Fluvial Flood Risk Note – Response to EA

MECD – Work Stage 3 Flood Levels Review

5983-ARP-00-XX-DN-C-000008
MECD Flood Levels

**FLOOD RISK REVIEW
MANCHESTER ENGINEERING CAMPUS, OXFORD ROAD**

Image 1 - estimated overland flow paths for Manhole 5 (viewed north)

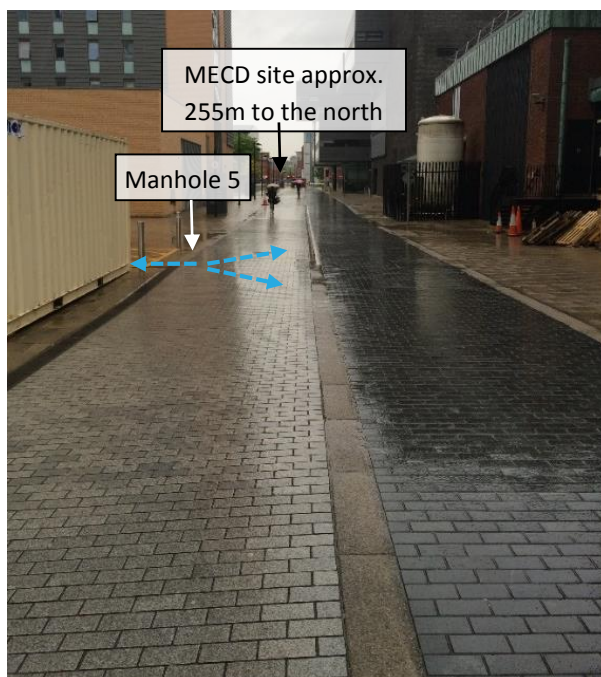
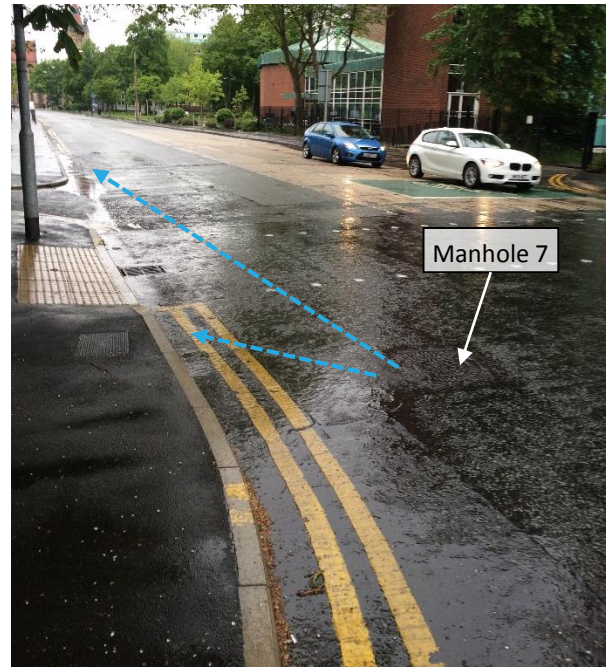
Based on the observed gradients overland flow from this MH, if surcharged, would flow west and north-east of the manhole. There is a relatively flat area located north-east of the manhole, which would encourage localised ponding of the water within this location; any flow passing this would flow towards Manhole 2*. Ground levels are very flat in this location and there is a large proportion of open amenity space to the north of MH5¹ of c. 28,500m². As a worst case estimate, this 450m³ of volume would equate to an average ponded depth c. 15mm and is therefore unlikely to reach the MECD site as it would first have to pass over kerbs and pavement areas within Booth Street East.

At this location, gradients and topography, show that potential surcharged Corn Brook water would flow directly west down Brunswick Street and ultimately, following the observed gradient, southwards down Oxford Road and away from the MECD development.

From this assessment, it is considered that the predicted surcharged volumes of floodwaters are unlikely to reach/affect the MECD site location for the 1:1000 year event.

sheet name:
Assessment of Overland Flood Risk

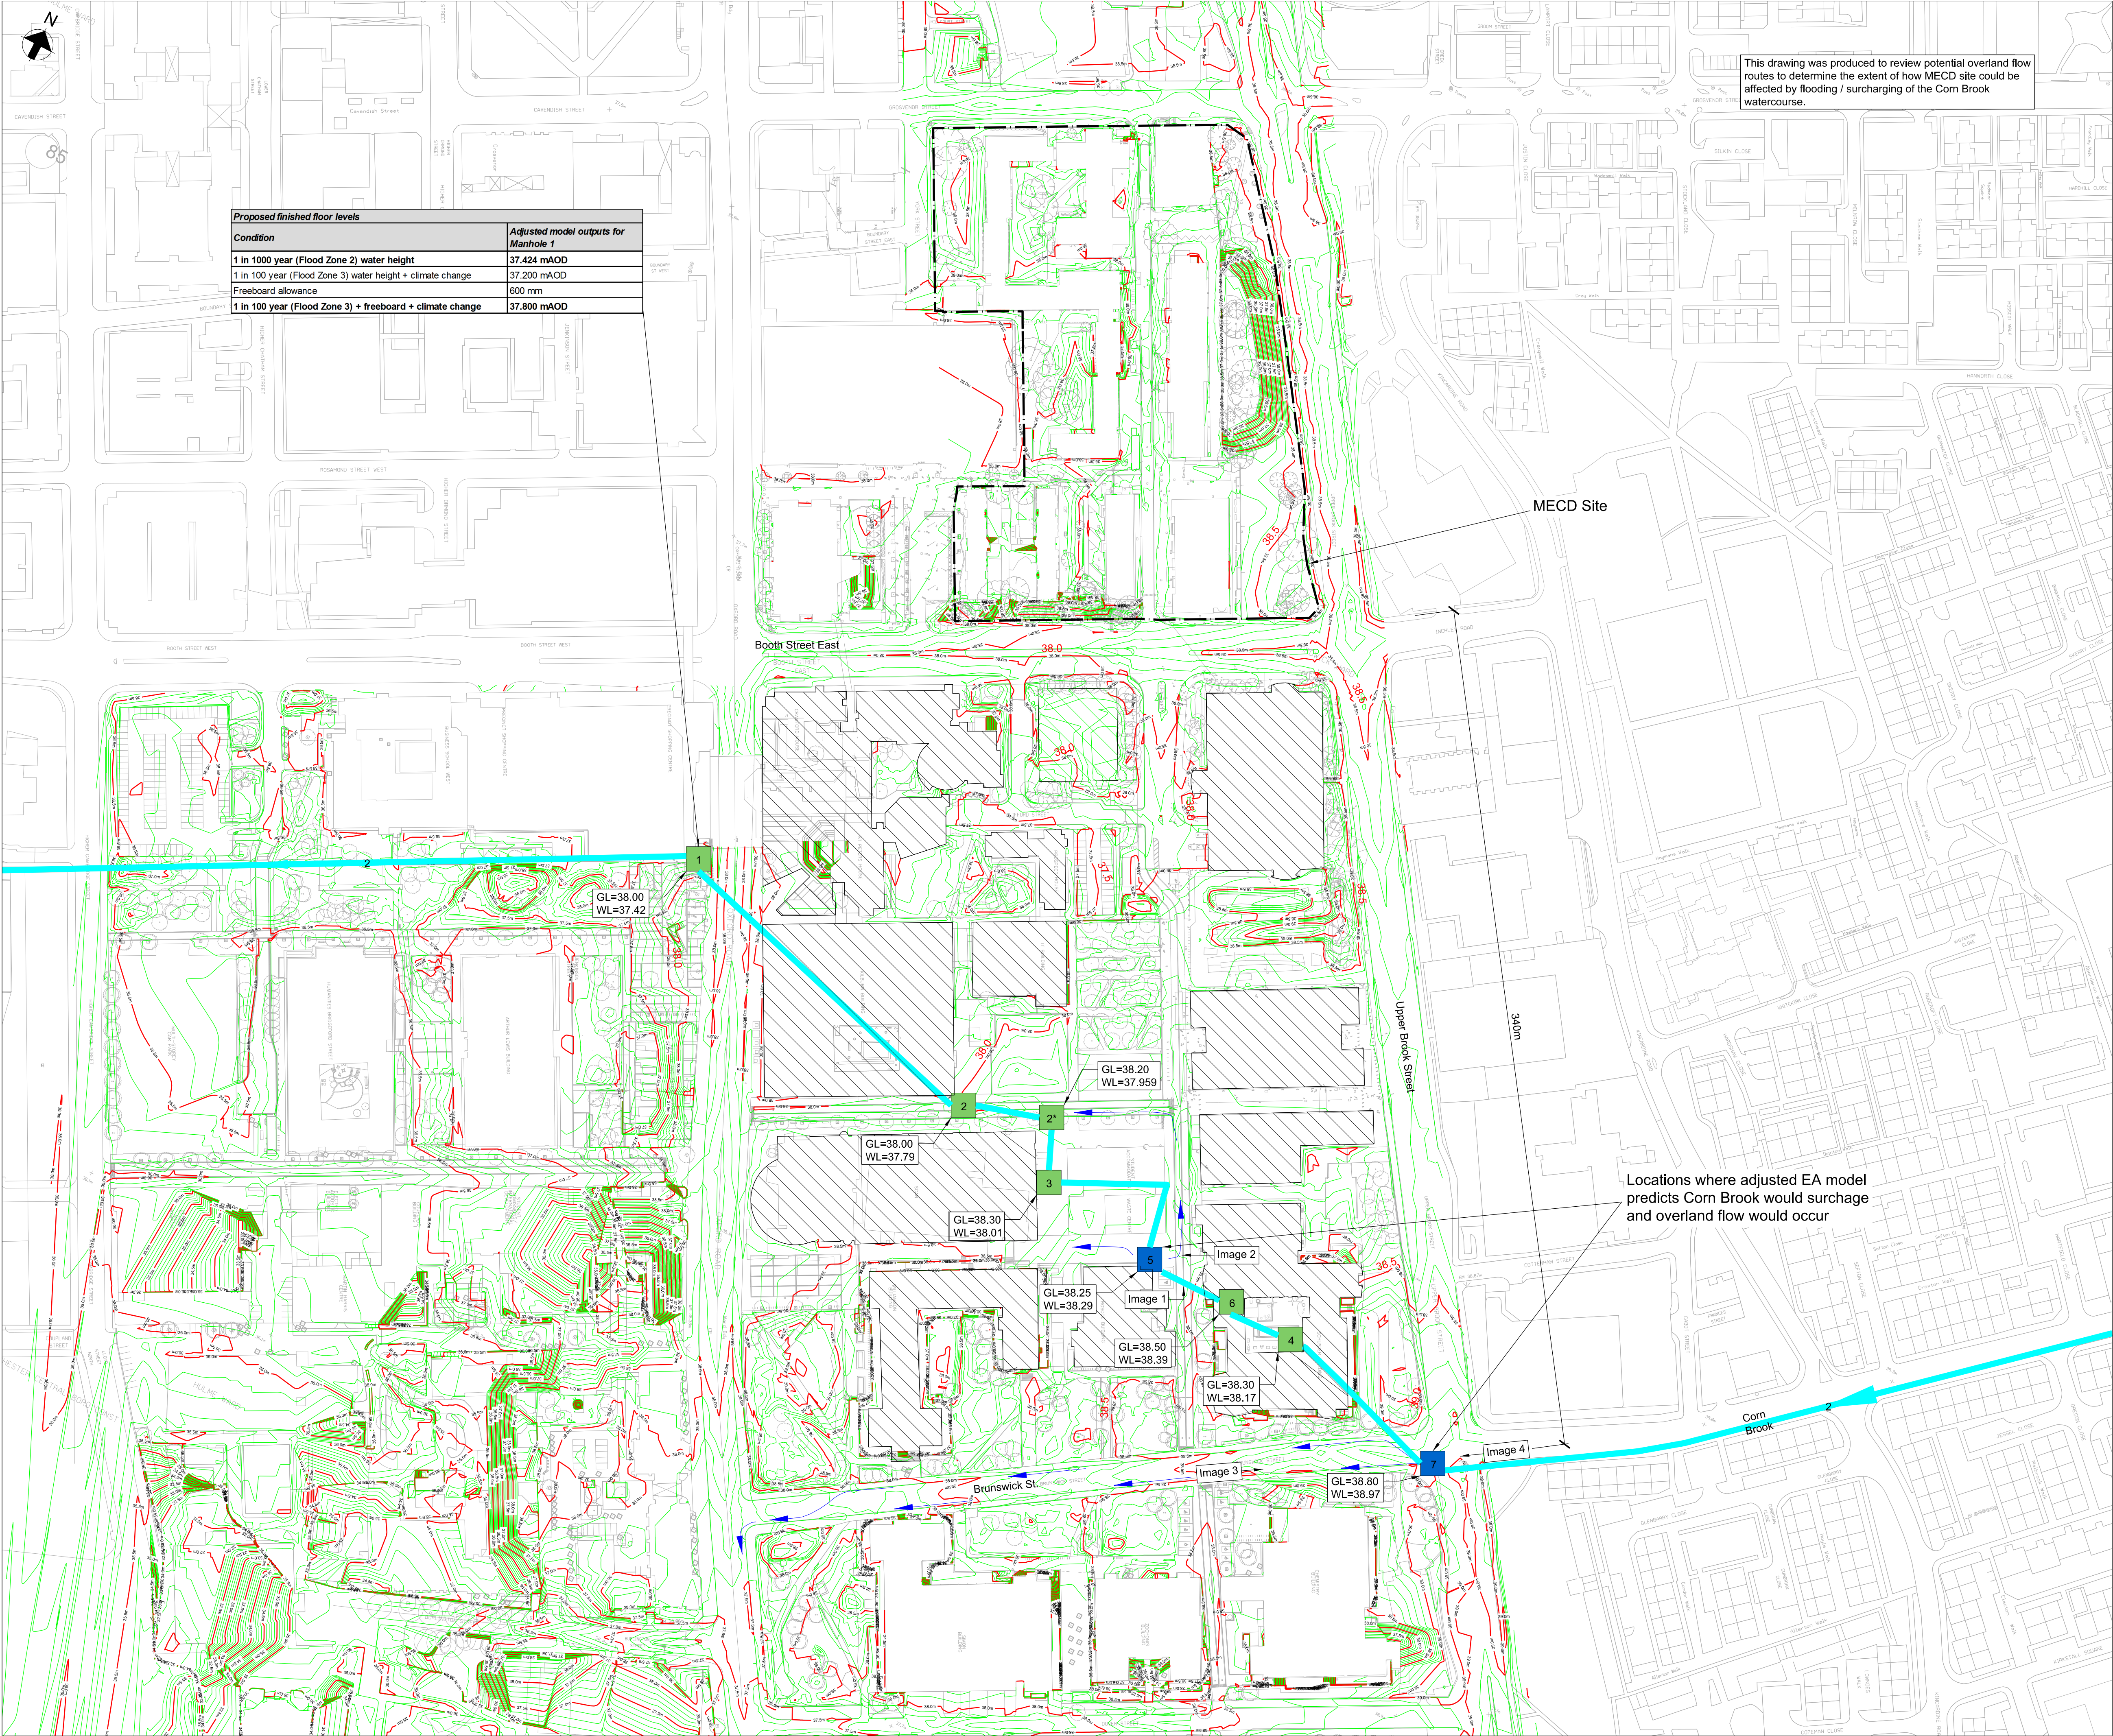
Referring to the drawing (ref: **5983-ARP-SW-GF-SI-CD-301001**) and photographs highlighted in **Images 1-4**, it is evident that:

Manhole 1 is located closest to the MECD site boundary and hence, has been used to determine the recommended finished floor level (FFL) for the development. Having simulated both the 1 in 1000 year and 1 in 100 year (plus 20% climate change) events within the adjusted EA model, the water heights detailed in **Table 2** were outputted for Manhole 1. These were used to determine a minimum FFL of **37.80 mAOD**, based on EA guidance.

The FFL for the MECD development is proposed such that it will tie in to the existing floor levels of the on-site buildings at **38.35 mAOD**. This is above the minimum recommended FFL and as such, is in accordance with the guidance provided by the EA.

- It is considered that any surcharged Corn Brook flood water, from Manholes 5 and 7, are unlikely to reach/affect the MECD site.
- The minimum FFL (based on EA guidance) for the development is determined as 37.80 mAOD. This is below the proposed FFL for MECD of 38.35 mAOD.
